### 3. TREES ON WILSON STREET

**Re: Arboricultural note for design changes**

**Site: Carriageworks, 35-47 Wilson Lane, Darlington NSW**

3. TREES ON WILSON STREET

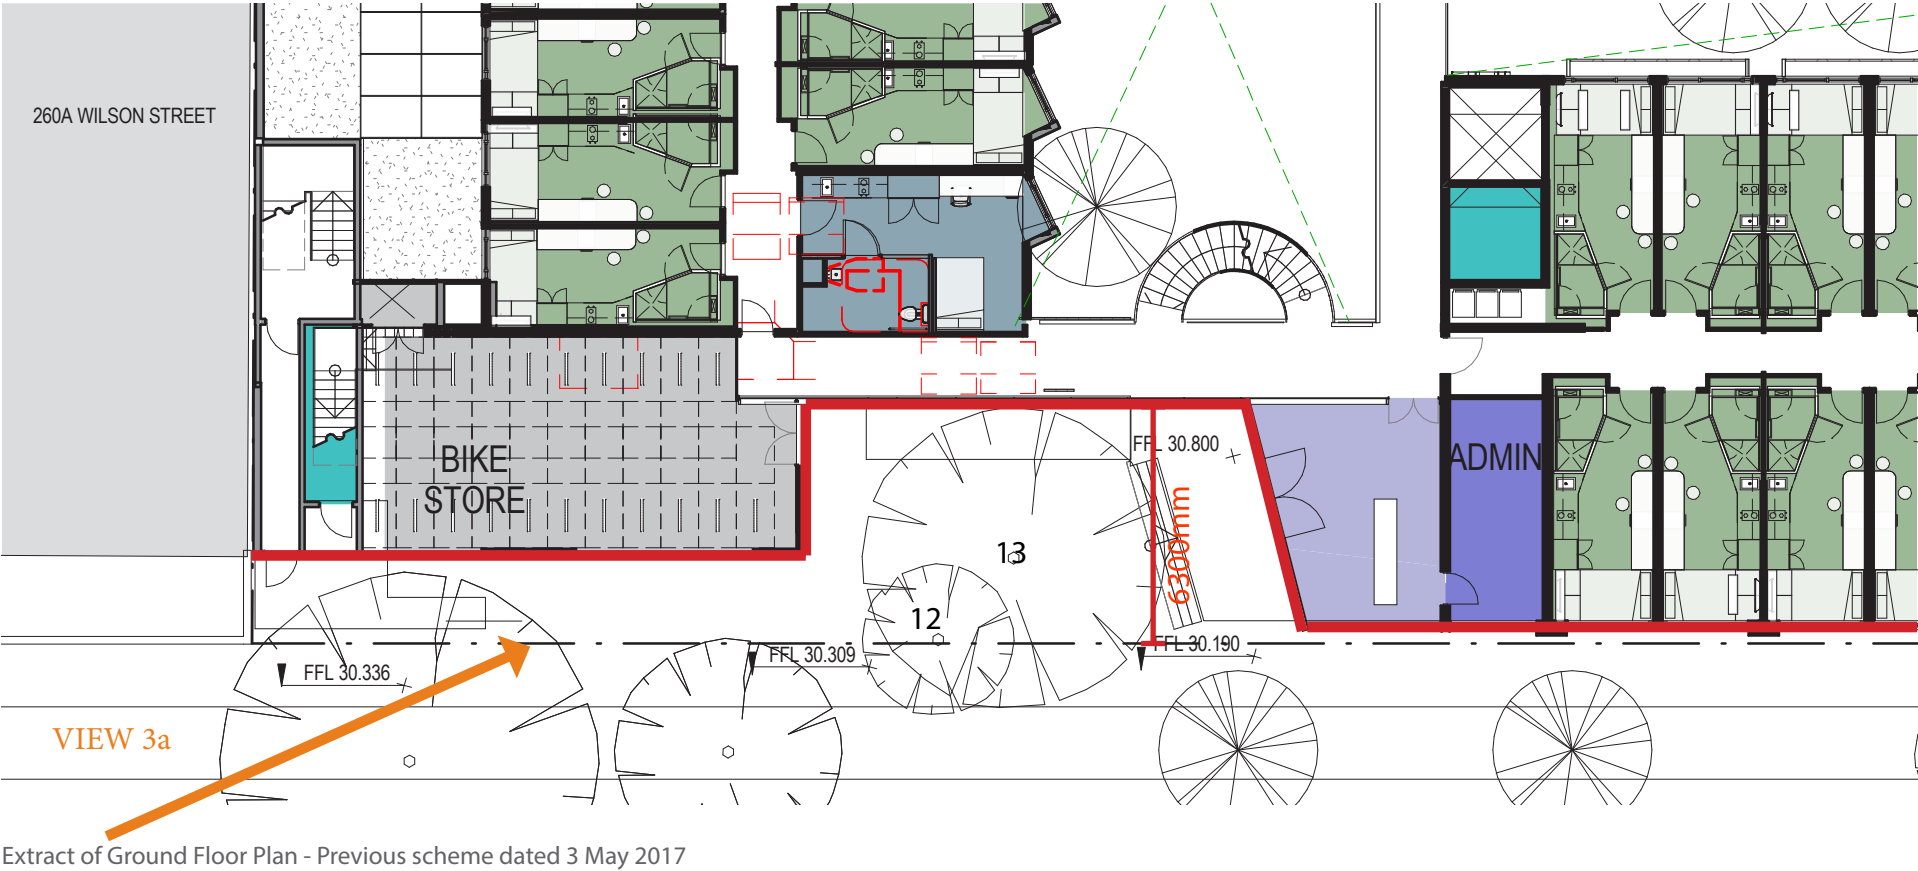
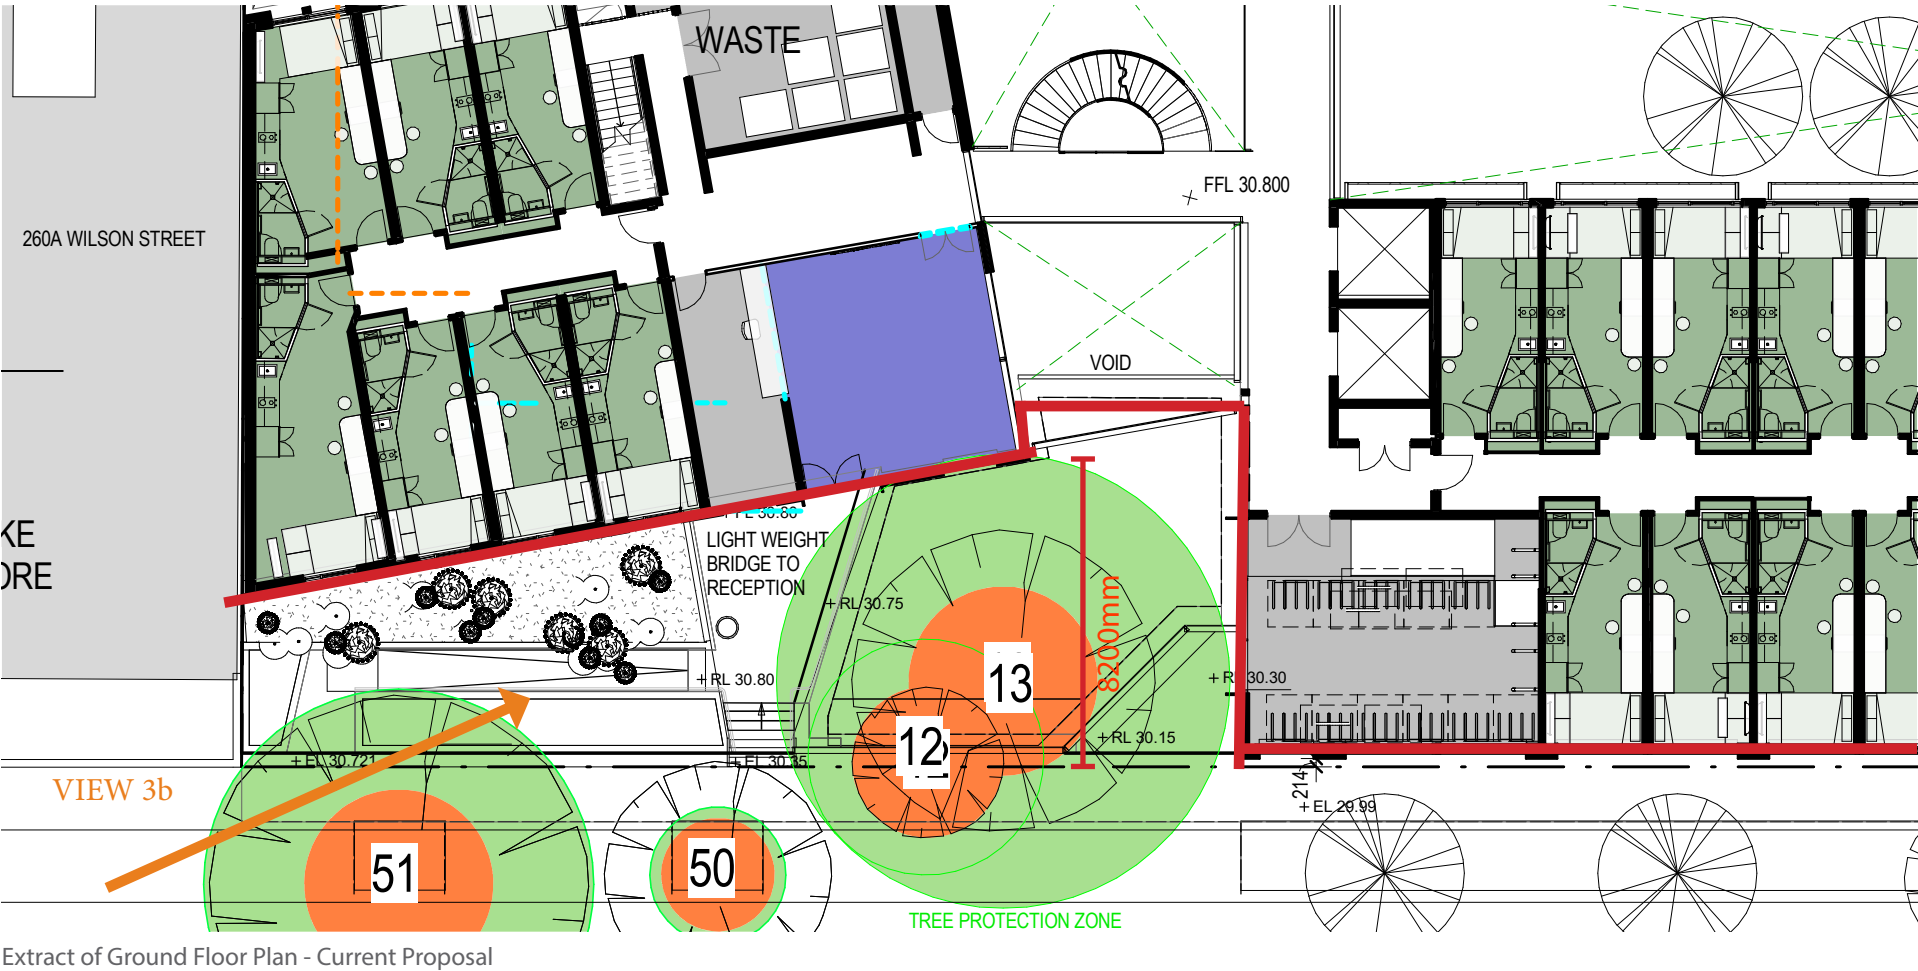
The setback to Wilson Lane, in the proximity of Tree 13, has been substantially increased as illustrated on the diagrams and views to the right.

View 3a : looking East along Wilson Street - Previous scheme dated 3 May 2017

View 3b : looking East along Wilson Street - Current Proposal

With regards to these trees the new designs show that all works are outside the TPZ distances for each tree. The ground floor plan and lower ground floor have had the TPZ and SRZ distances applied to them and can be seen on the last page of this letter.

Trees 12 and 13 have no incursions to the TPZ areas however there is a small pedestrian foot bridge that will cross the TPZ area for these trees from Wilson Street. Provided this bridge can be constructed on piers that do not require strip footings the impacts to these trees will be minimal. Both trees are likely to require selective target pruning, with specified maximum diameter pruning cuts, in order to maintain a constant height for pedestrian access.

4. TREE NUMBER 1

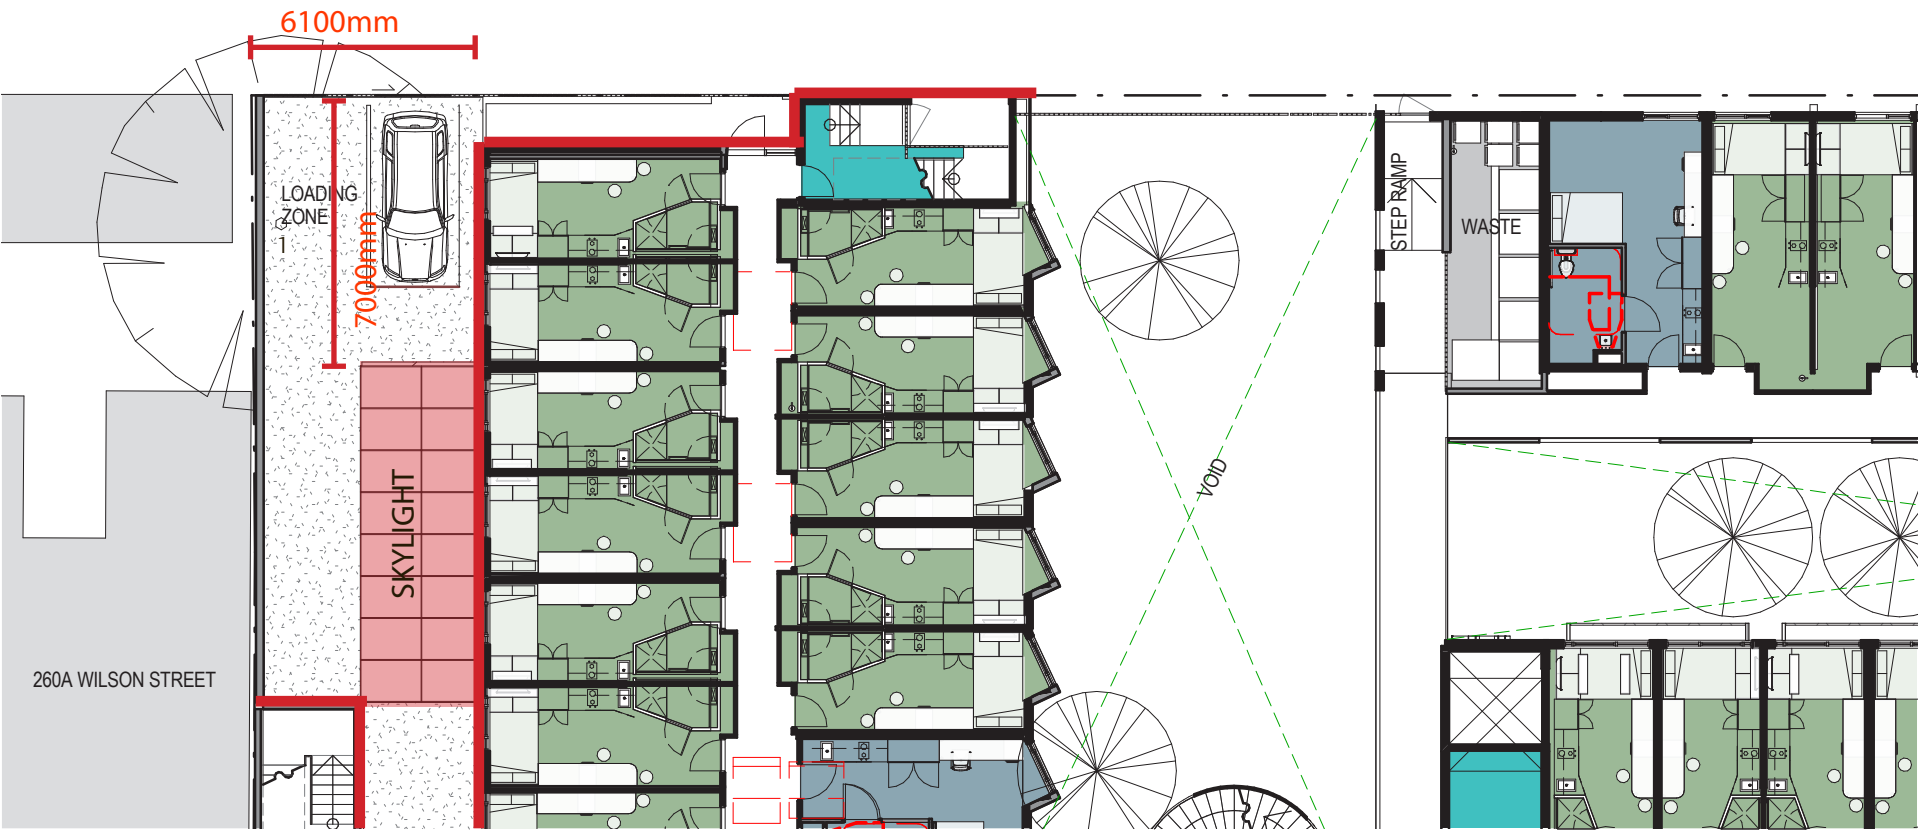
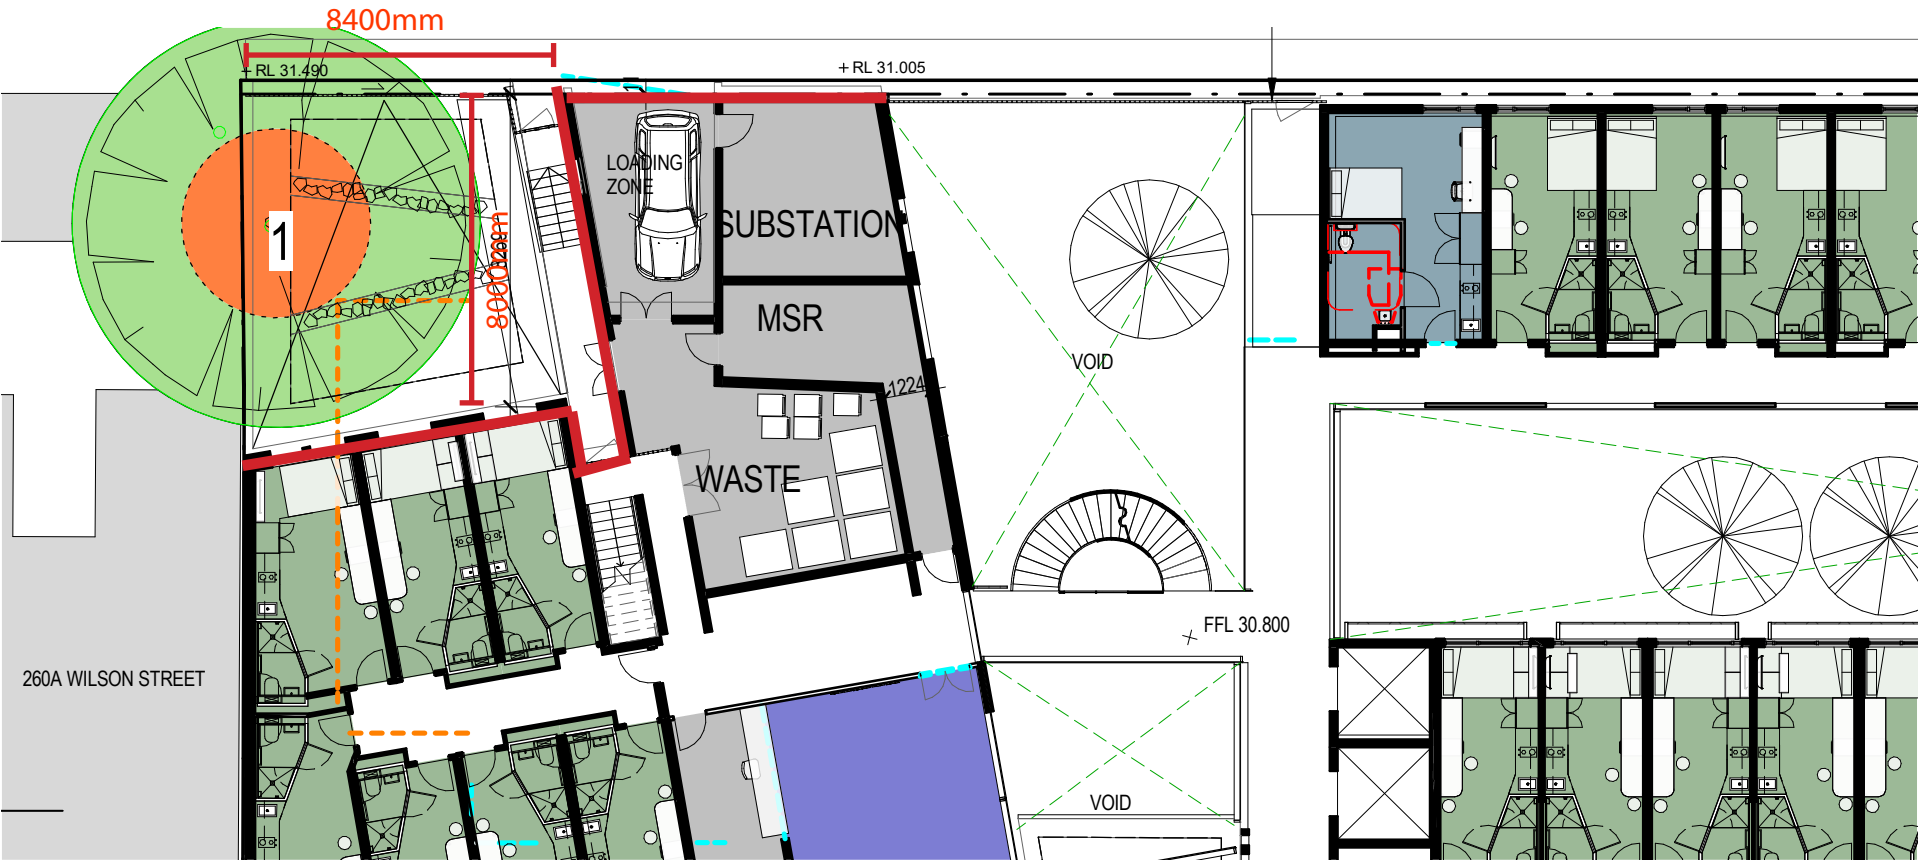
The design of the building near Tree 1 has been substantially amended to increase setback and improve amenity around Tree 1. The previous and current setbacks are illustrated in the diagrams to the right.

The building line has been moved a further 2300mm from the western boundary. Furthermore the loading bay is now incorporated within the building envelope and not within the setback zone as previously proposed. The current proposal removes any potential conflict between a vehicle and the low branches.

The skylight to the lower ground floor has been removed therefore reducing any possible impact on the structural root zone. The common room has been reconfigured to ensure the space has plenty of natural daylighting.

The reconfiguration of this area has also substantially reduced any potenital overlooking to the western neighbour.

Designs have now been altered around Tree 1 to move all building works outside the TPZ for this tree. Provided tree protection measures are implemented this tree should not be affected by the proposed works.
